**HISTORIC PRESERVATION COMMISSION
FEBRUARY 24, 2022
ASSEMBLY HALL**

**PINEHURST, NORTH CAROLINA
4:00 PM**

- I. Call to Order
- II. Approval of Minutes
 - A. 01-27-2022 Special Meeting Minutes
 - B. 01-27-2022 Regular Meeting Minutes
- III. Public Hearing
 - A. COA-2022-00037 (25 DOGWOOD RD)

Partial Elevation "B":

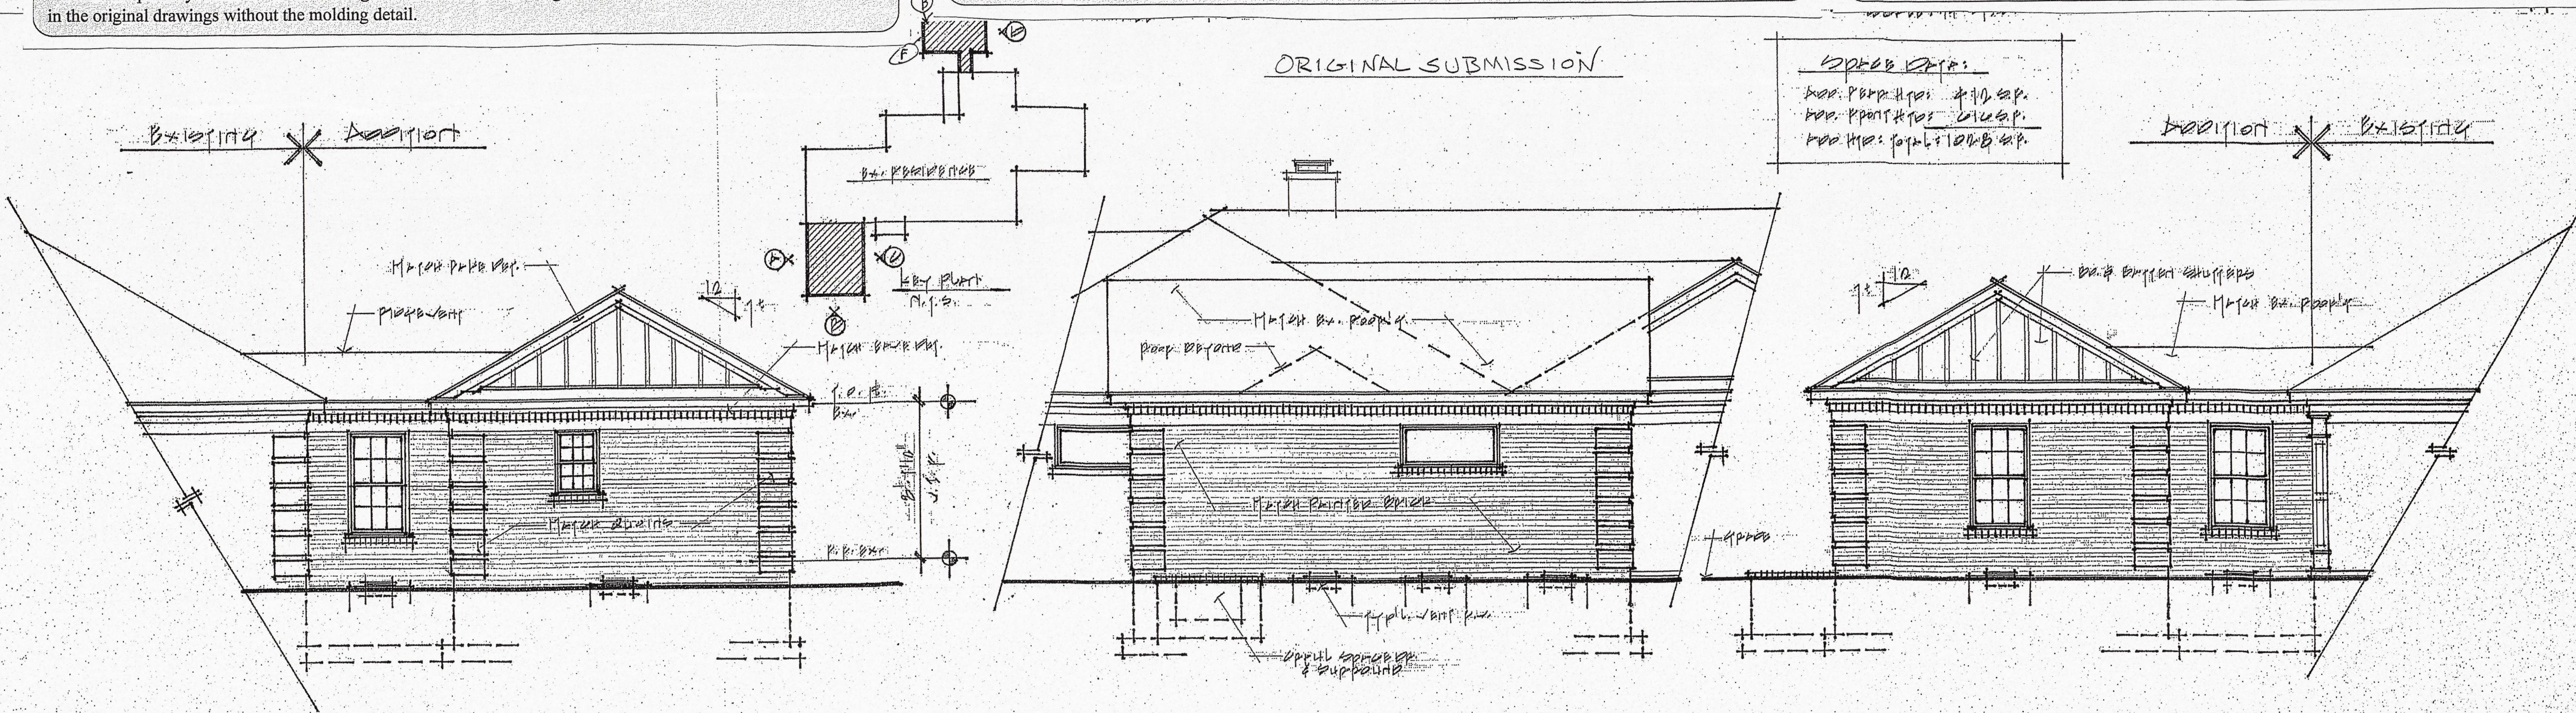
The addition has shifted to the south, 6'8". This elevation shows the west facing wall of the new addition which includes the back wall of a bedroom and the side wall of a powder room. The bathrooms are now on the south side of the bedroom. The long 5' window that was in the original plan, has been centered on the bedroom that shifted north. A small bathroom window was added.

Proposed changes to the previously approved rear addition (Exhibit A-3)

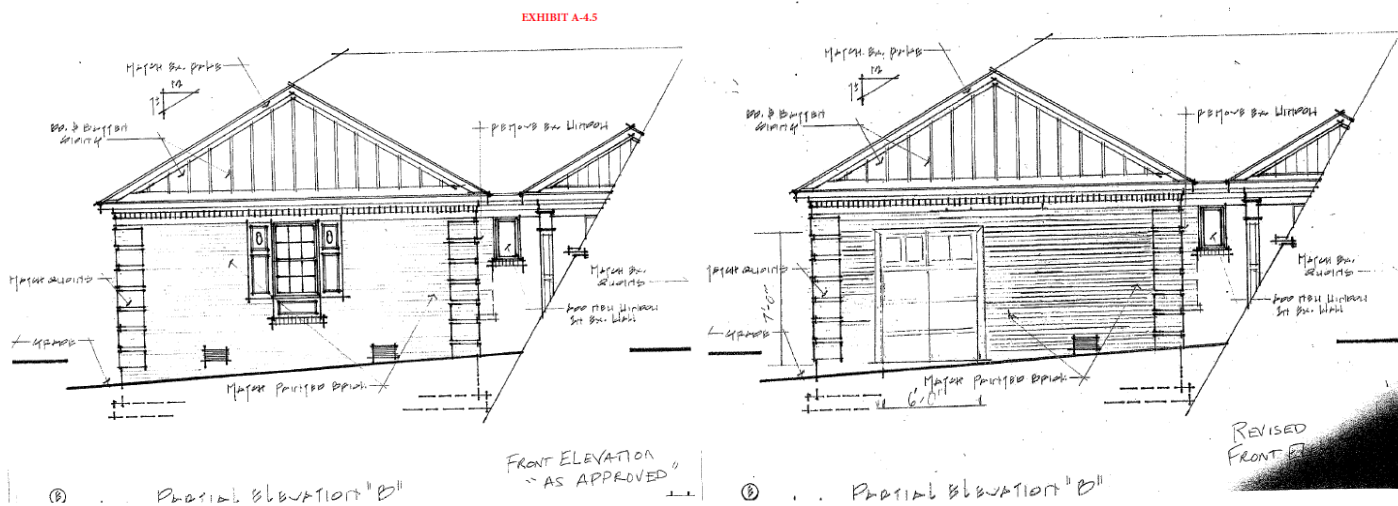
5. Section III.I.5 – New features, such as windows or door openings, bays, vents, dormers, roof forms, balconies, chimneys, or other details *should* not be introduced on existing carriage houses, garages, or buildings if they are incompatible with the primary structure.
6. Section III.I.6 – Windows and doors in additions and accessory buildings *should* be similar to those in the existing primary structure in their proportions, spacing, and materials.
7. Section III.I.9 – Additions and accessory buildings such as carriage houses, garages and other buildings **must** be located as inconspicuously as possible, in rear or side yards.
8. Section III.I.10 – An addition **must** not obscure, damage, or destroy the character-defining features of an historic primary structure.
9. Section III.I.12 – Attached or detached garages *should* open to the rear or side of the primary structure.

Provided photo rendering looking to proposed wall from Shaw Road (Exhibit A-3.2)

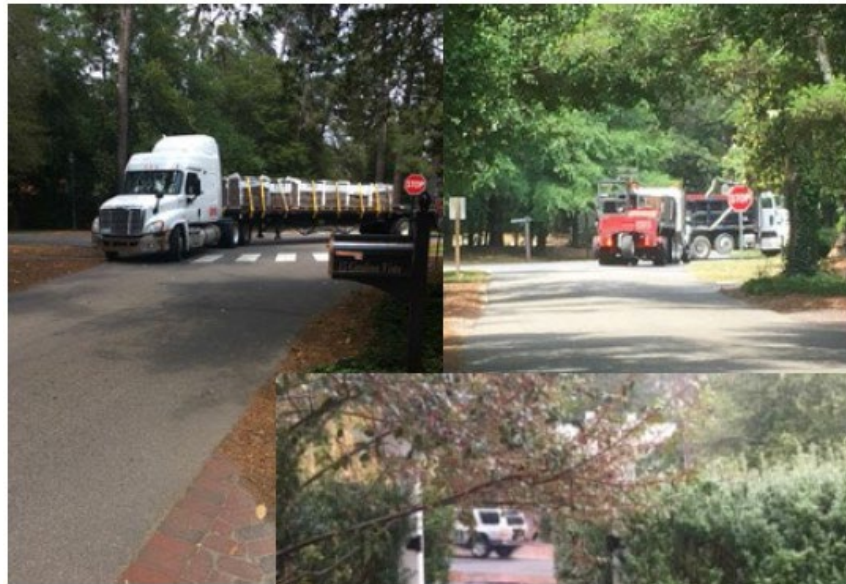
EXISTING SIDE ARBOR with PROPOSED NEW PRIVACY WALL
